## Architect's Supplemental Instructions

Center for Forensic Psychiatry - Construct  
Kitchen  
8303 Platt Rd, Saline, MI 48176

ASI Number: 2

Date: 02-17-2025

**M2.01**

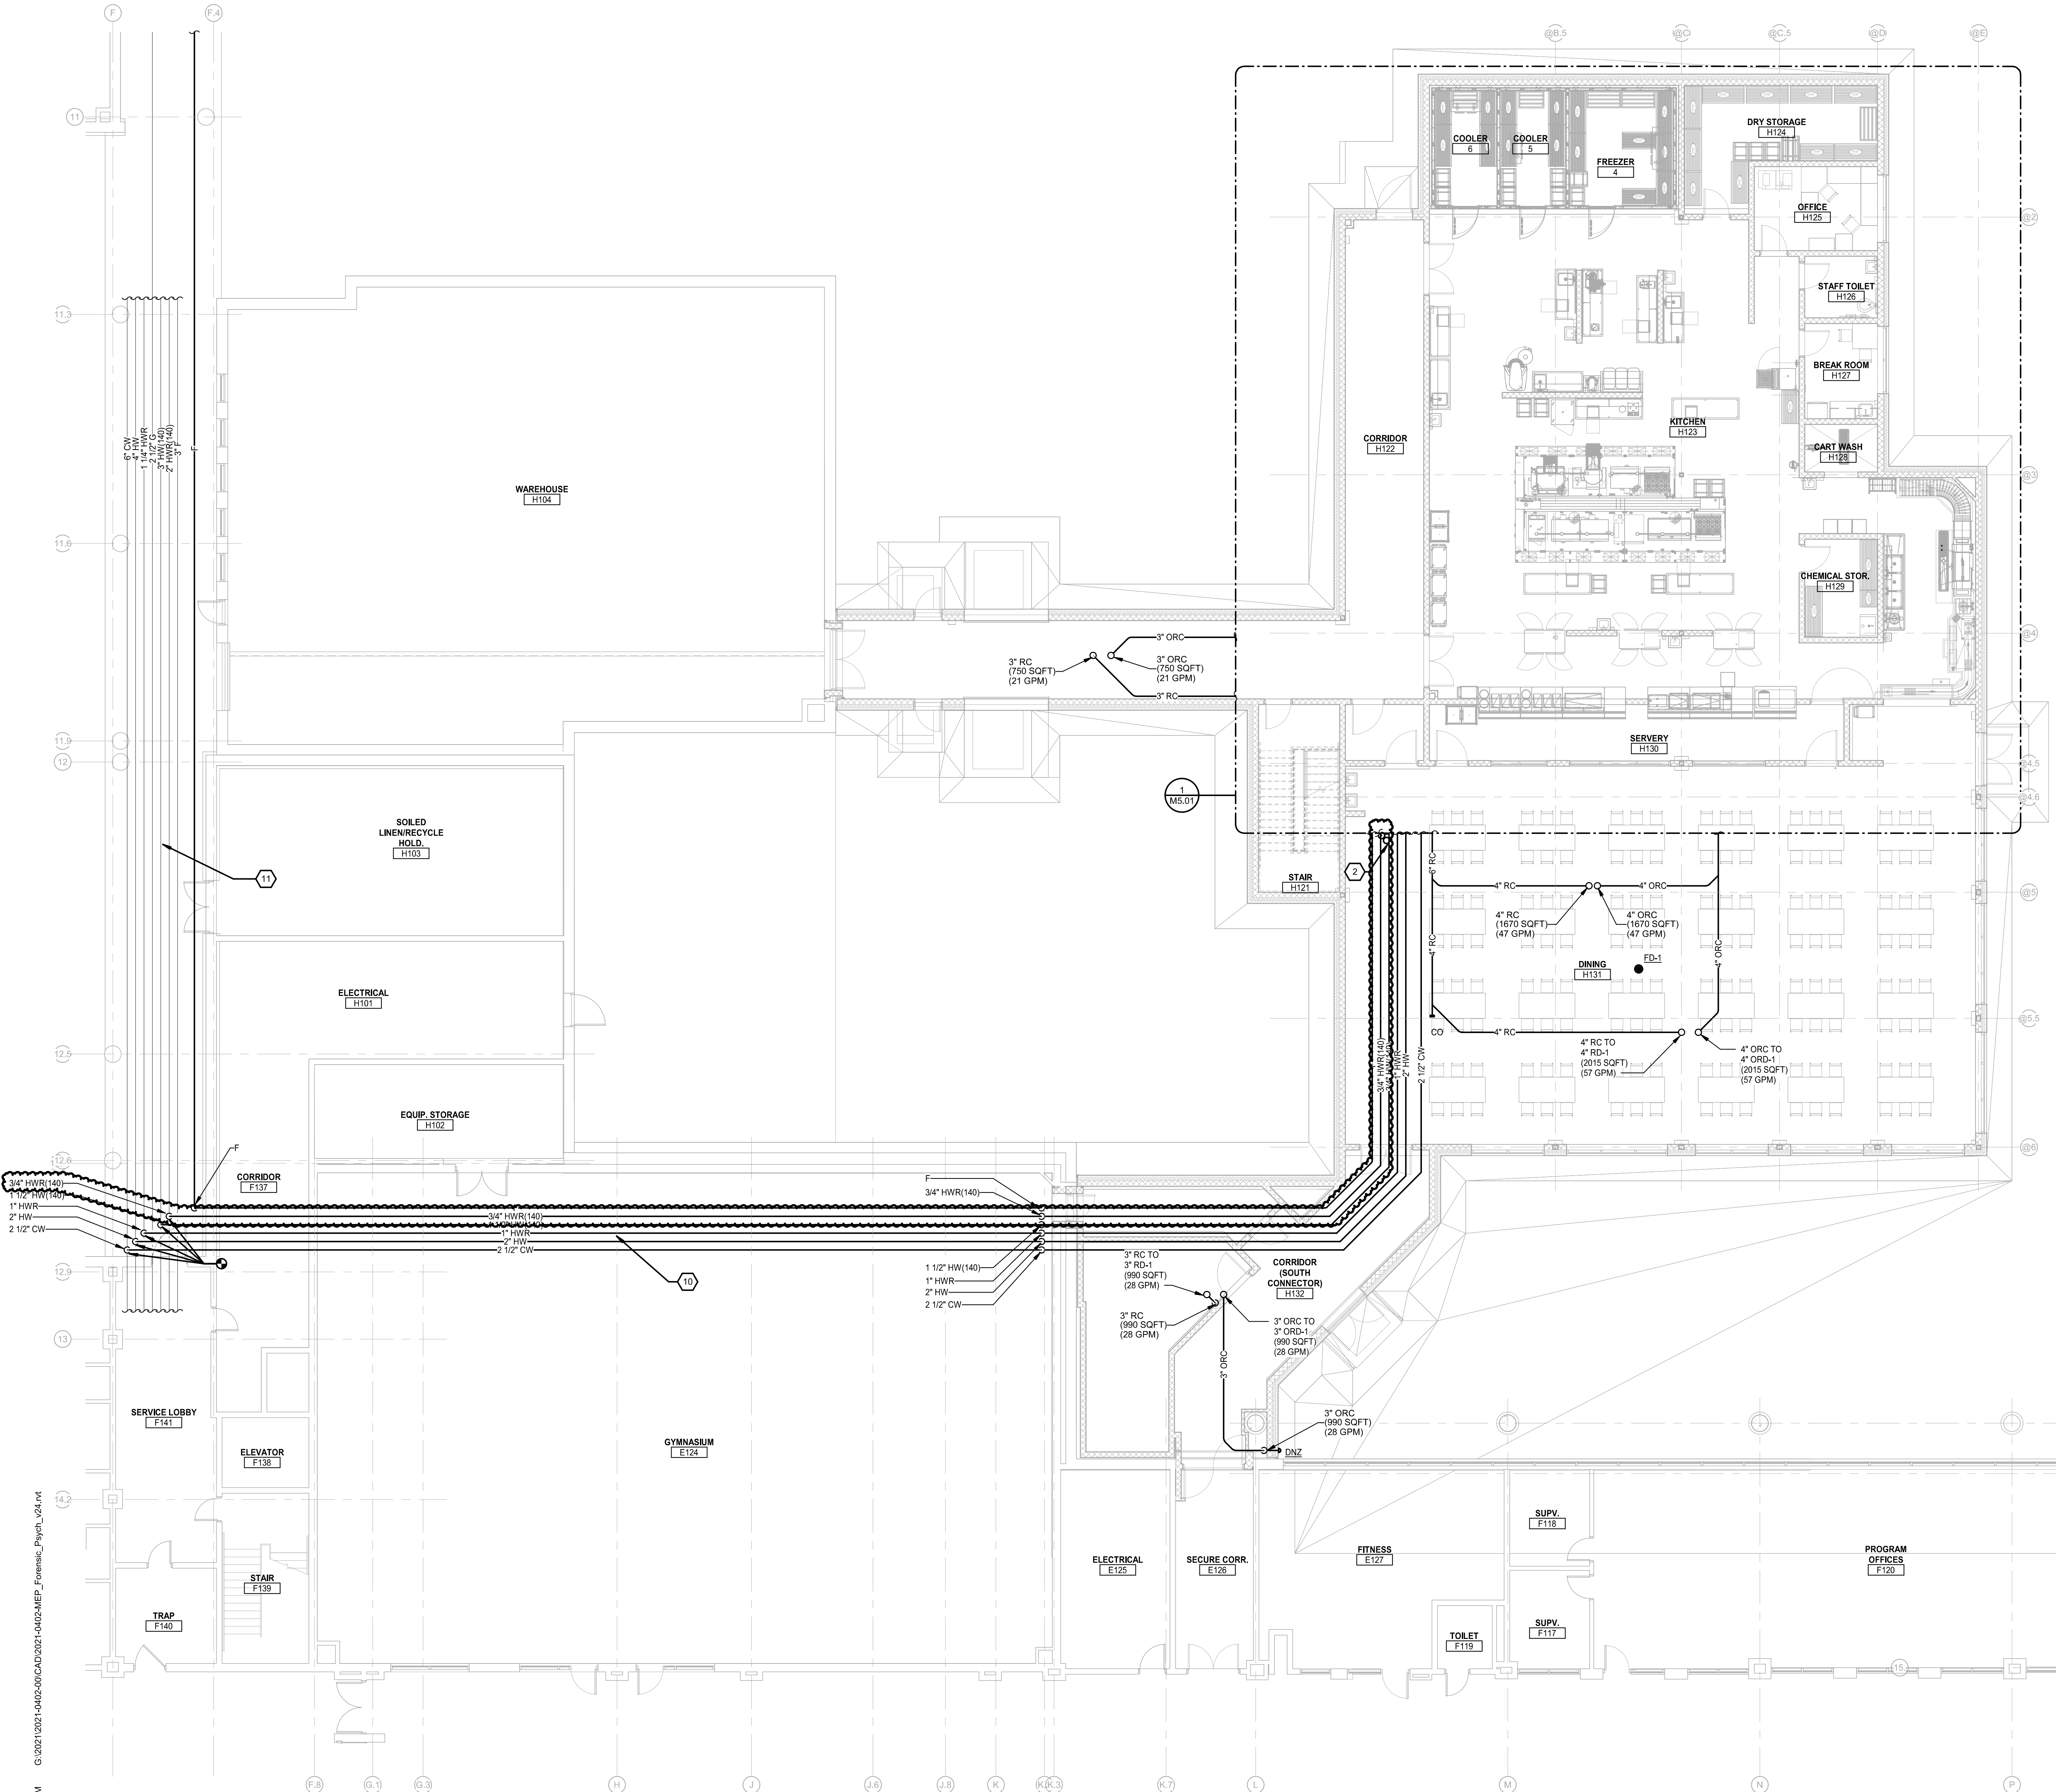
Item M1: Reference Sheet M2.01 (Re-Issued)

Added 3/4" HWH (140) routing from kitchen to main per RFI #61.

**M3.01**

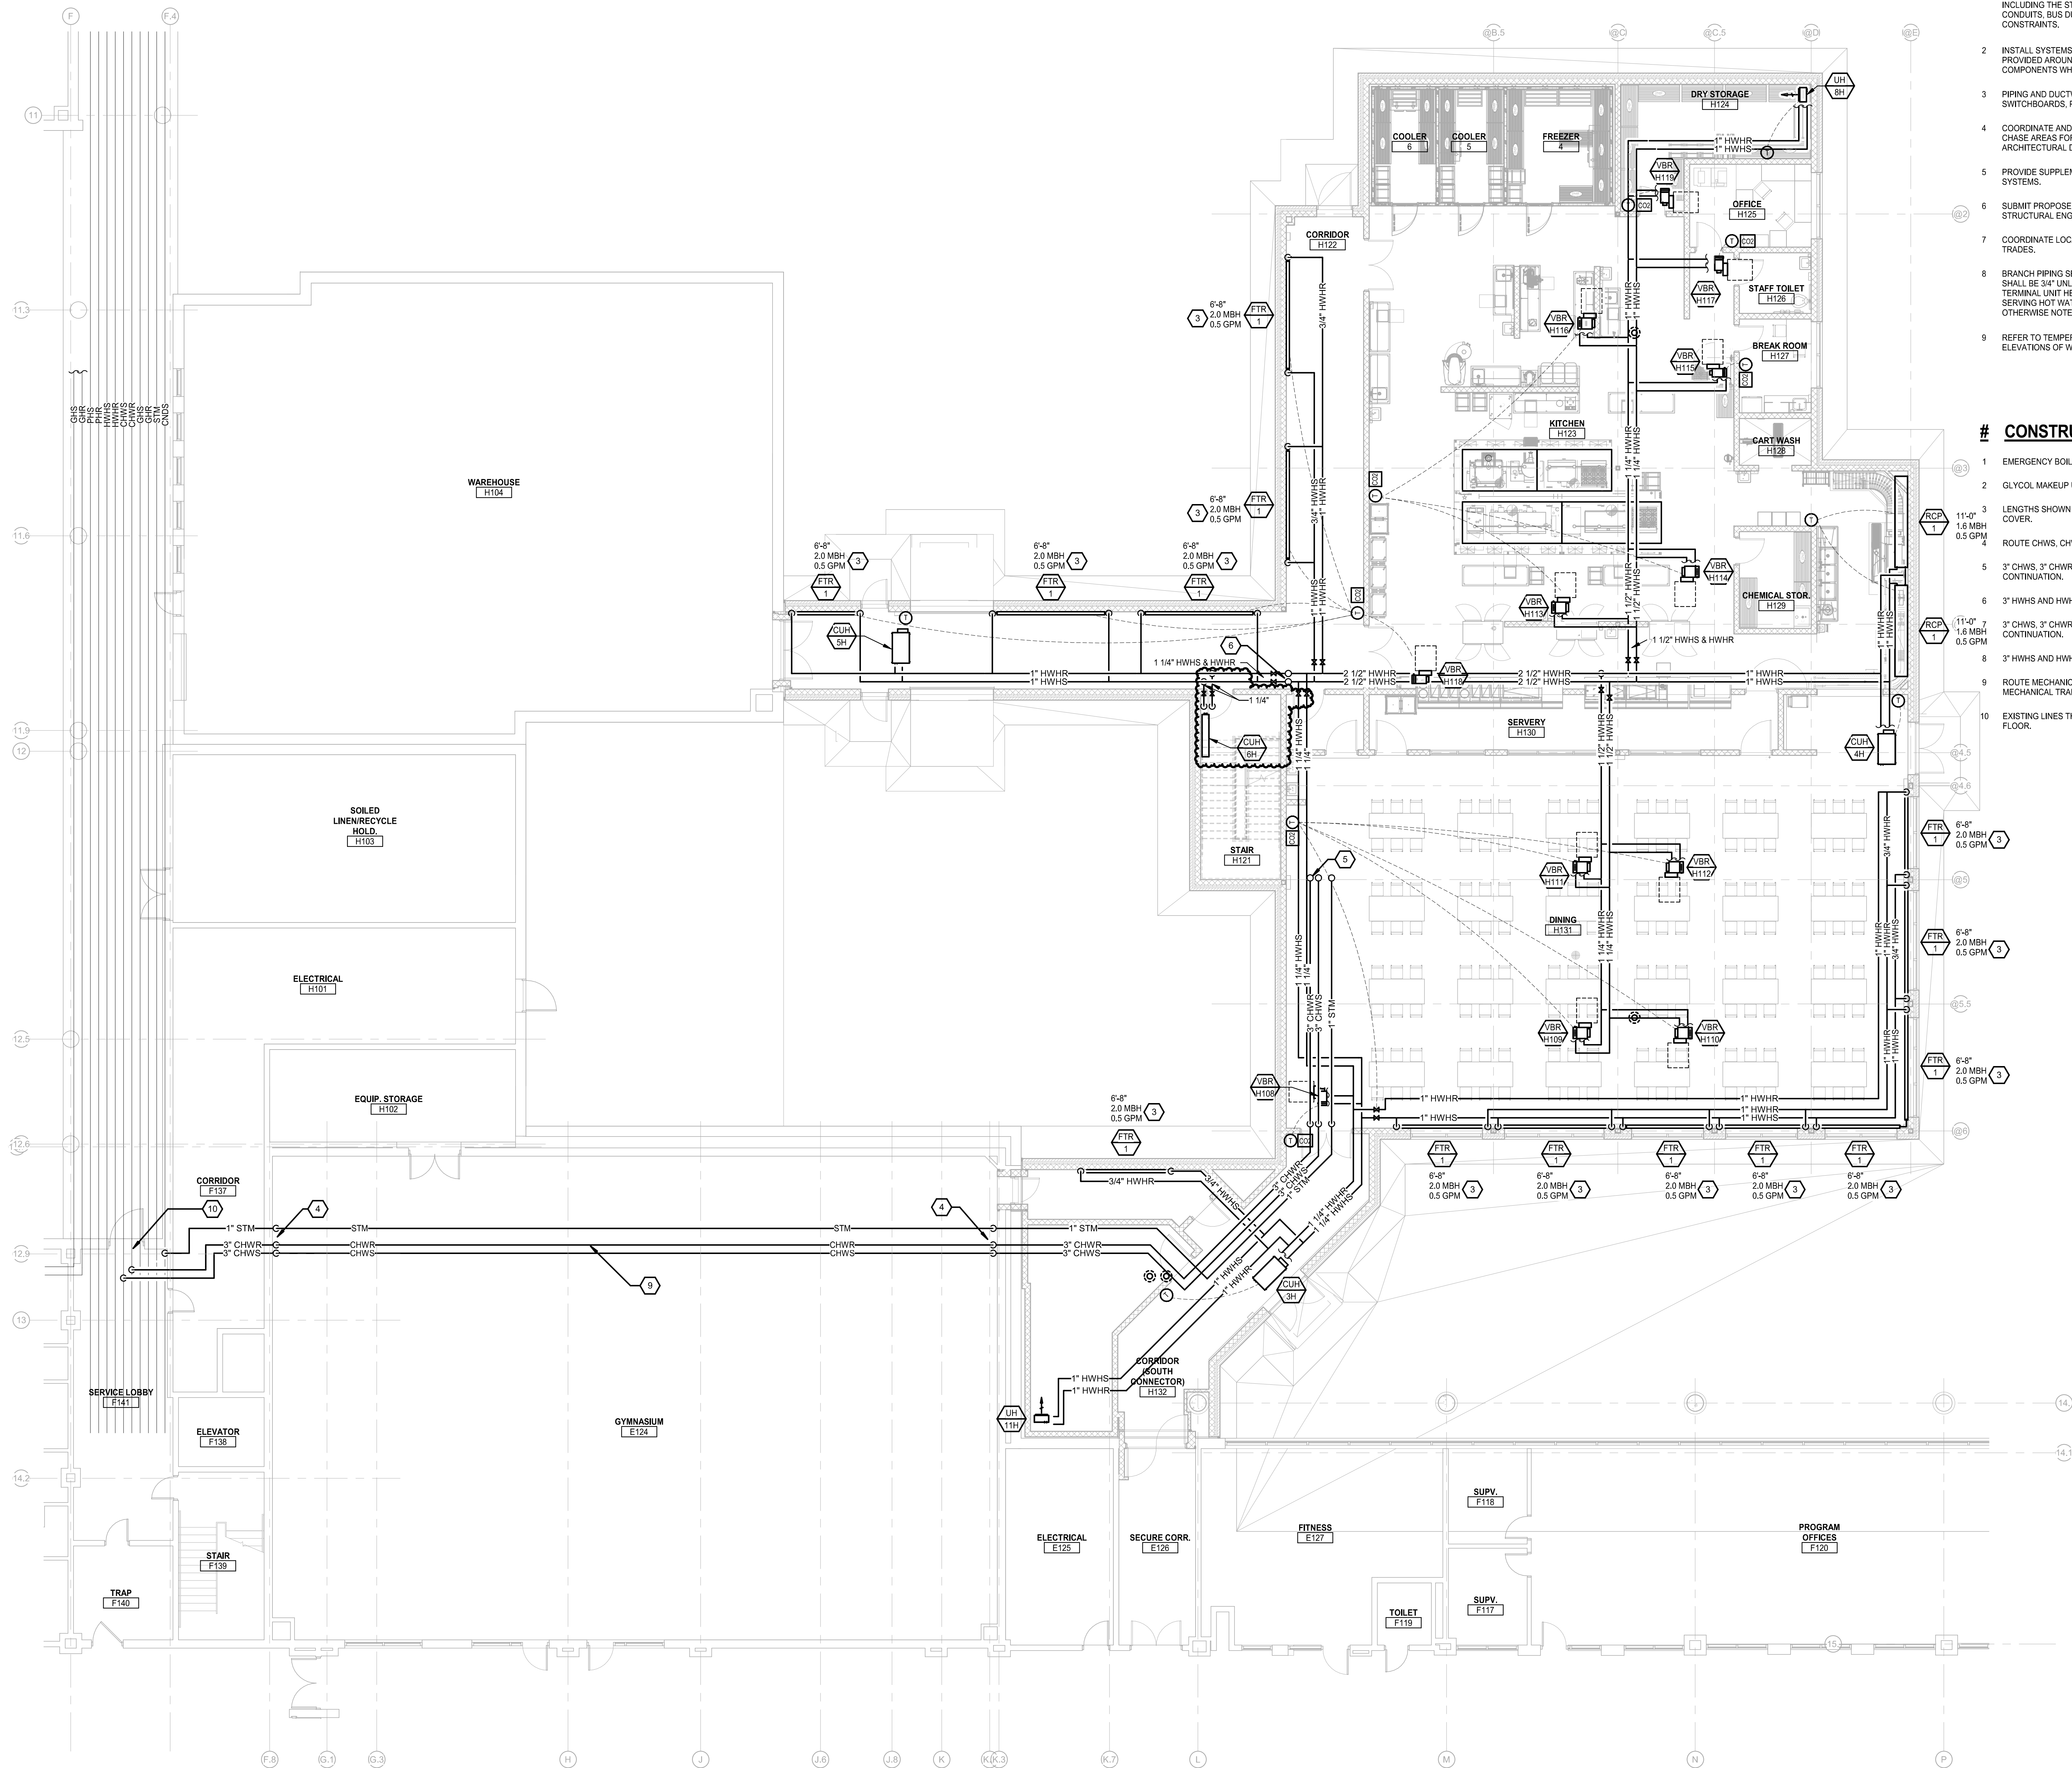
Item M2: Reference Sheet M3.01 (Re-issued)

Moved cabinet unit heater (CUH) 6H to opposite side of stairwell as indicated.

E0.02

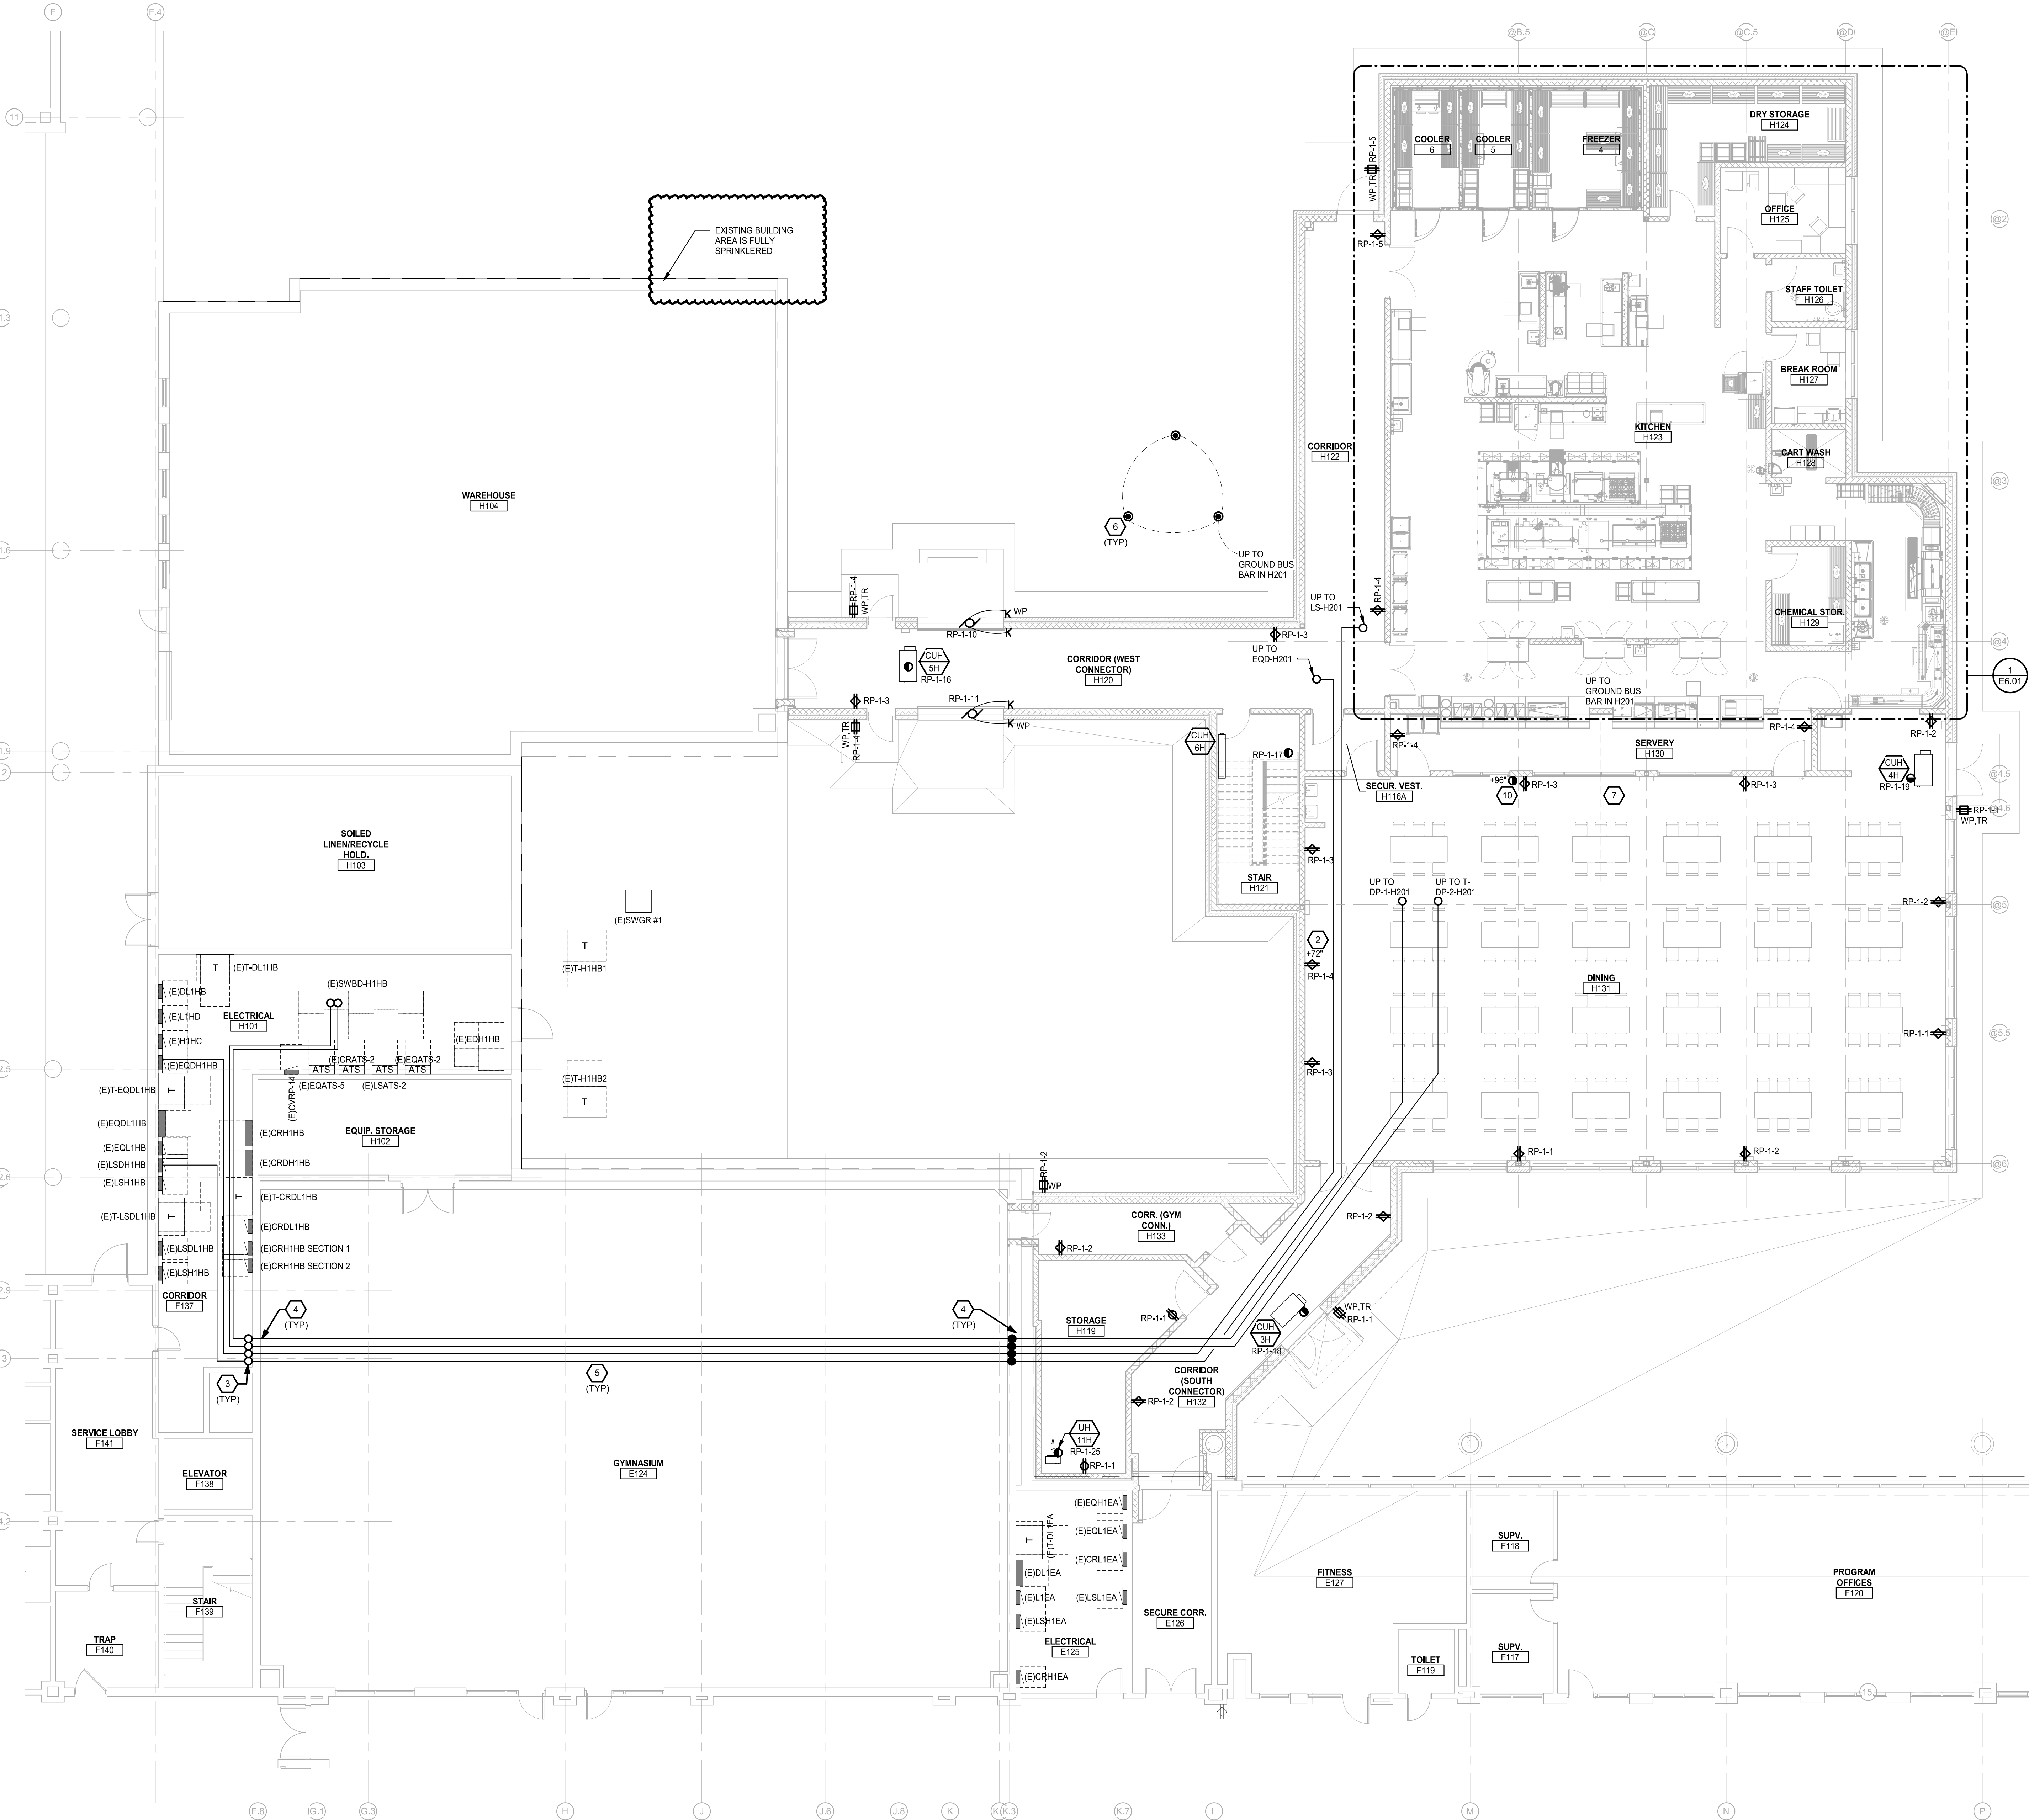
Item E1: Reference Sheet E0.02 (Re-Issued)

Removed the 2 houring rating wiring column to align with existing building and new addition construction.
